MEMORANDUM

TO: File 65-13157 and 65-13896

SUBJECT: Licensing Review for 65-13157 and 65-13896

Permits 65-13157 and 63-13896 place of use map

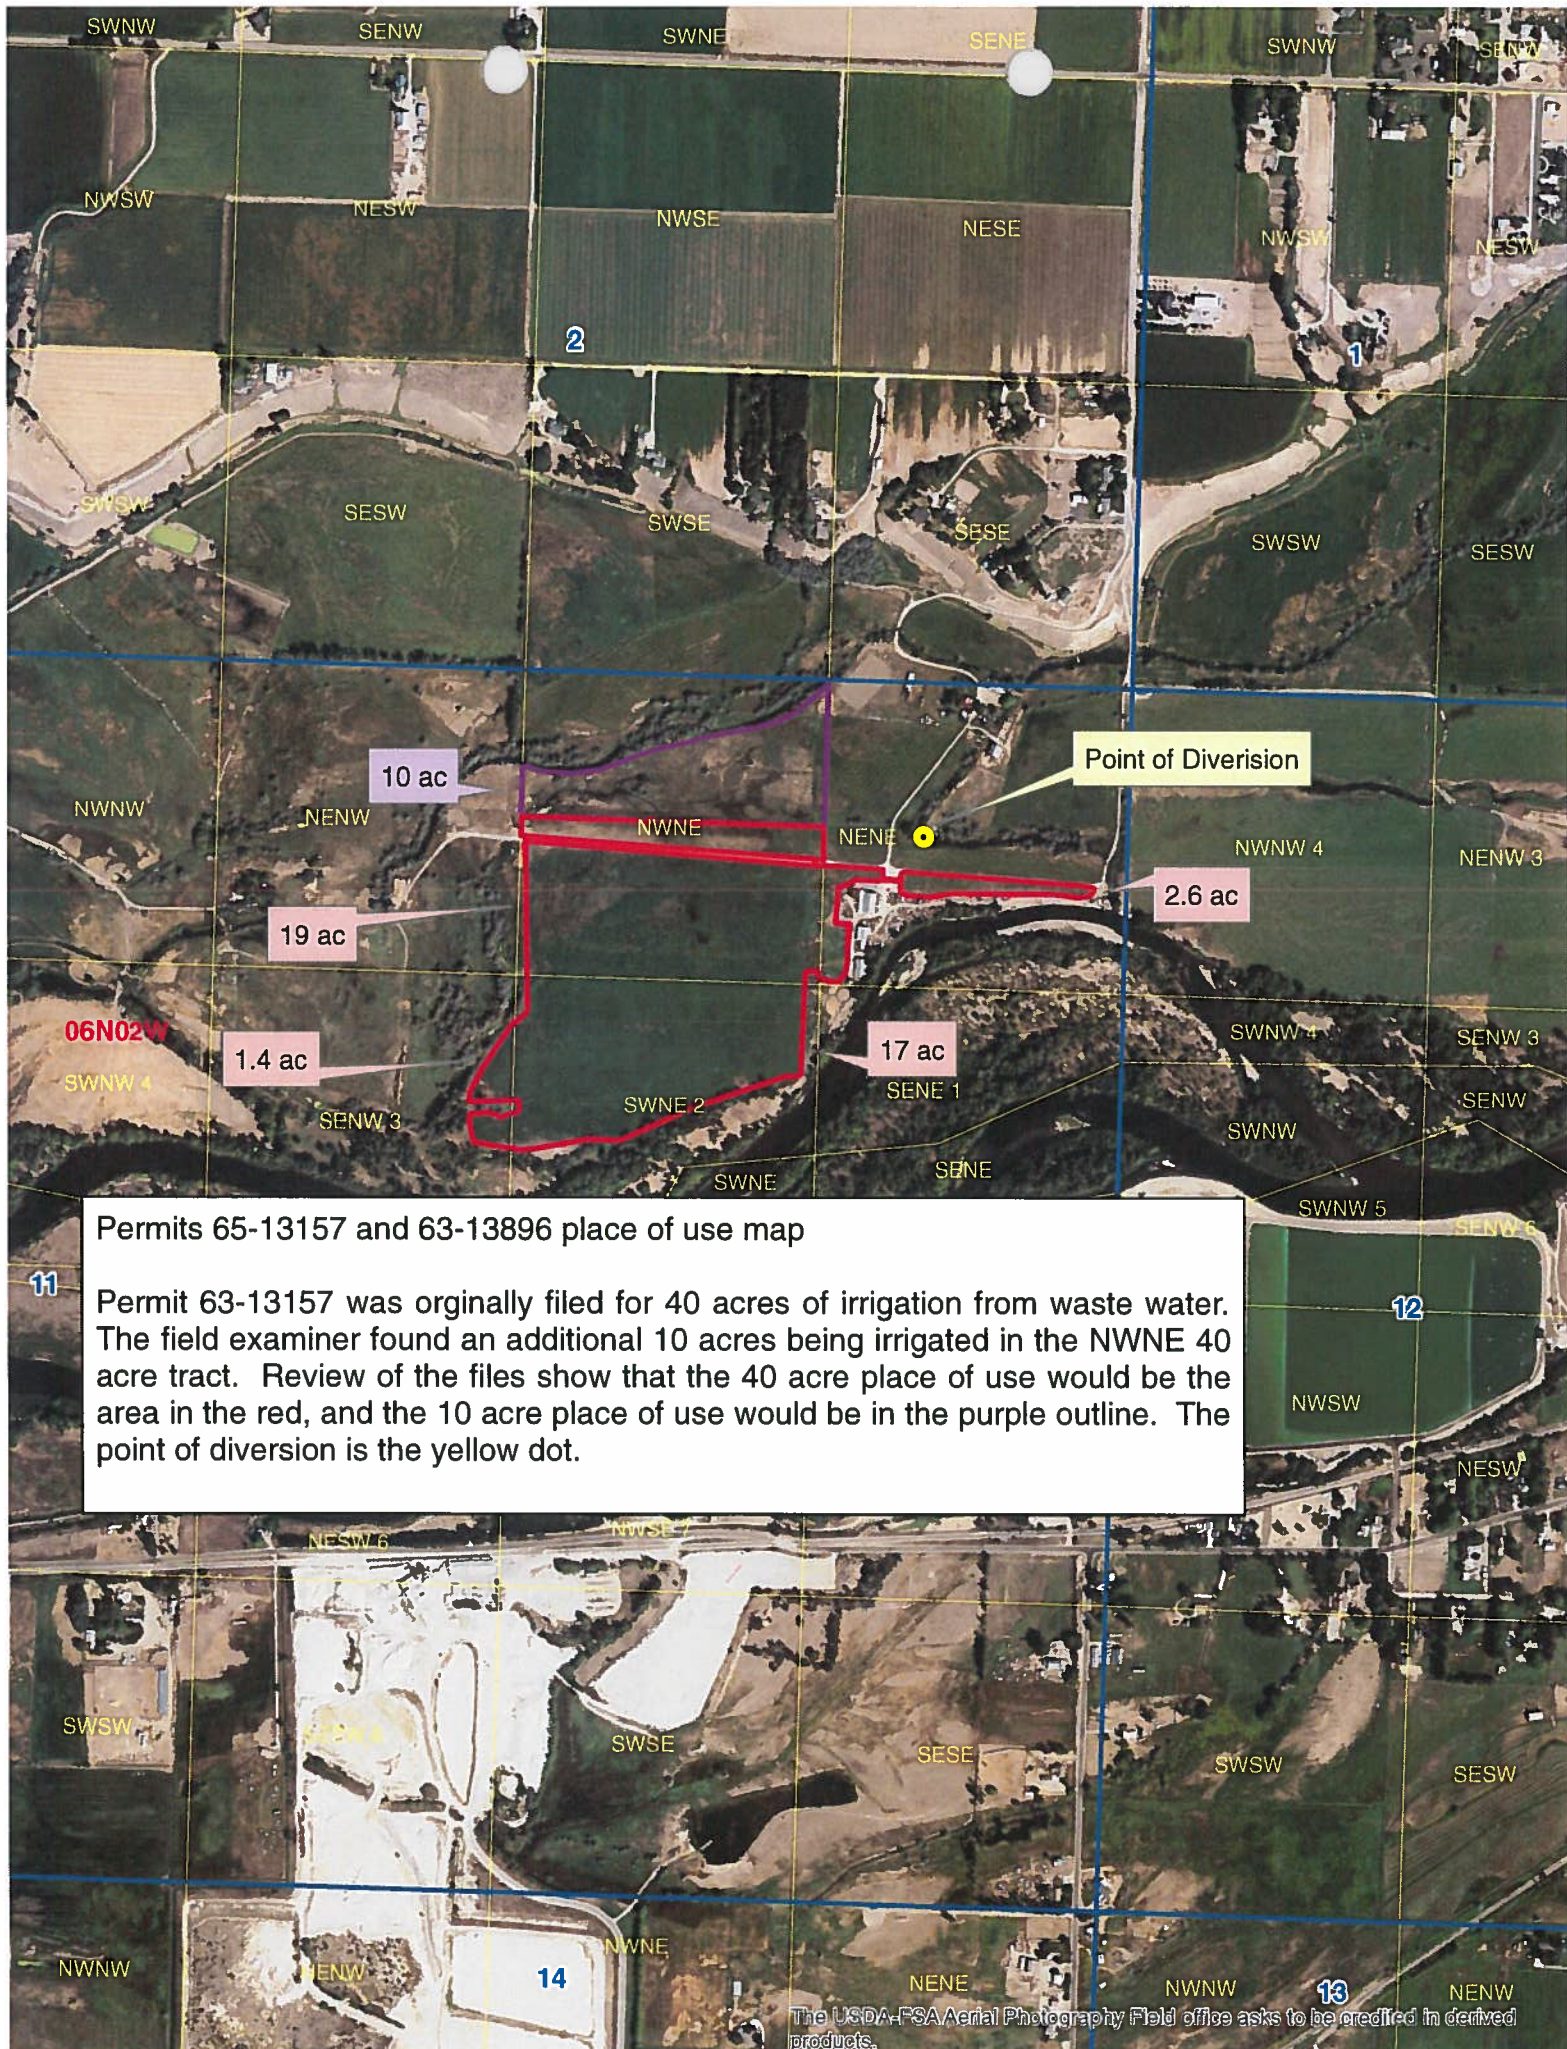
Permit 63-13157 was originally filed for 40 acres of irrigation from waste water. The field examiner found an additional 10 acres being irrigated in the NWNE 40 acre tract. Review of the files show that the 40 acre place of use would be the area in the red, and the 10 acre place of use would be in the purple outline. The point of diversion is the yellow dot.

Permits 65-13157 and 63-13896 Overlap Map

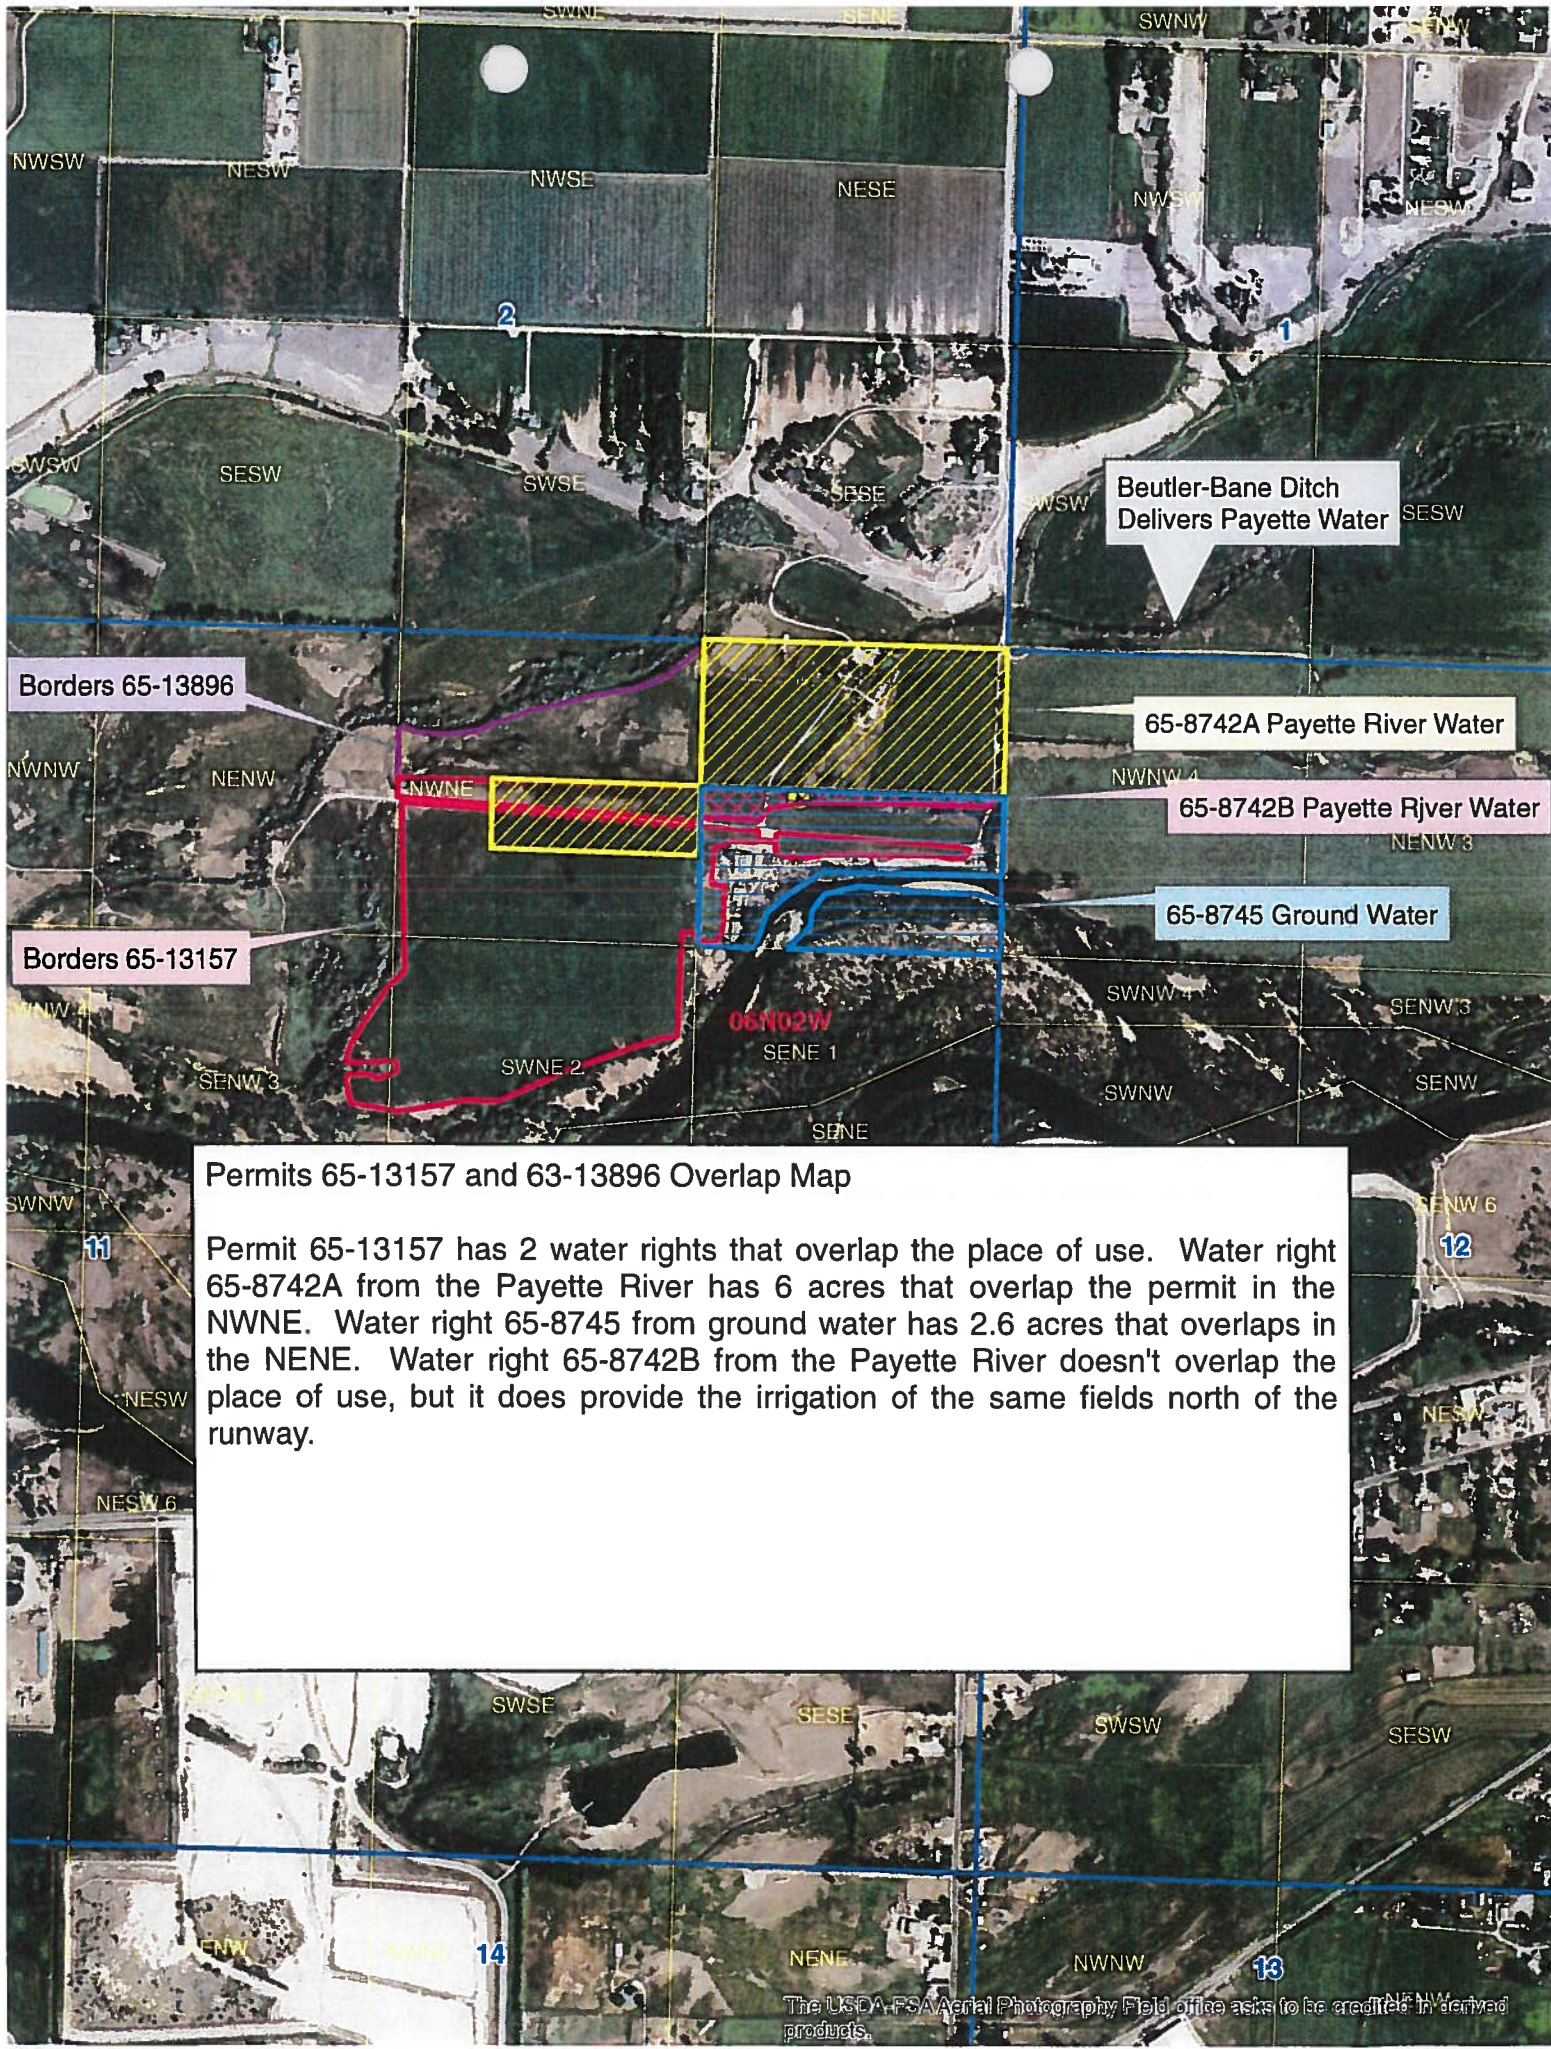
Permit 65-13157 has 2 water rights that overlap the place of use. Water right 65-8742A from the Payette River has 6 acres that overlap the permit in the NWNE. Water right 65-8745 from ground water has 2.6 acres that overlaps in the NENE. Water right 65-8742B from the Payette River doesn't overlap the place of use, but it does provide the irrigation of the same fields north of the runway.

65-13157 and 65-8742A when combined should be limited to 60 acres. The diversion rate for 8742A has a diversion rate of 1.216 cfs of which 0.334 cfs is allocated to conveyance losses. The diversion allowed from 65-8742A at the field headgate would be 0.882 cfs. Water Right 65-13157 adds an additional 0.080 cfs, but 6 of those acres are already covered by water right 65-8724A. so water right 65-13571 can only provide an additional 0.68 cfs $[(0.80 \text{ cfs} / 40 \text{ acres} = 0.02 \text{ cfs}) \times 34 \text{ acres} = 0.68 \text{ cfs}]$. The total combined diversion rate for 65-13157 and 65-8742A would then be 1.90 cfs $(1.216 \text{ cfs} + 0.68 \text{ cfs} = 1.896 \text{ cfs})$. The field headgate requirement is 1.56 cfs $(0.88 \text{ cfs from } 65-8742A + 0.68 \text{ cfs from } 65-13157 = 1.56 \text{ cfs})$ when the two rights are combined.

65-13157 and 65-8742B do not overlap each other, but the 2 acres irrigated by 65-8724B are completely overlapped by 65-8745. However, since 65-13157 and 65-8742B do not overlap, it isn't prudent to include a diversion rate restriction on water right 65-8742B in a condition in 65-13157.

65-13157 and 65-8745 when combined should be limited to 55.4 acres. There is no conveyance losses accounted for in these two water rights, so they would need to be limited to a diversion rate of 1.11 cfs $(0.02 \text{ cfs} \times 55.4 \text{ acres} = 1.108 \text{ cfs})$.

A condition should be added to tie in all of the combined water rights. When water rights 65-8742A, 65-8742B, 65-8745, and 65-13157 are combined, they are limited to a total of 85.4 acres.
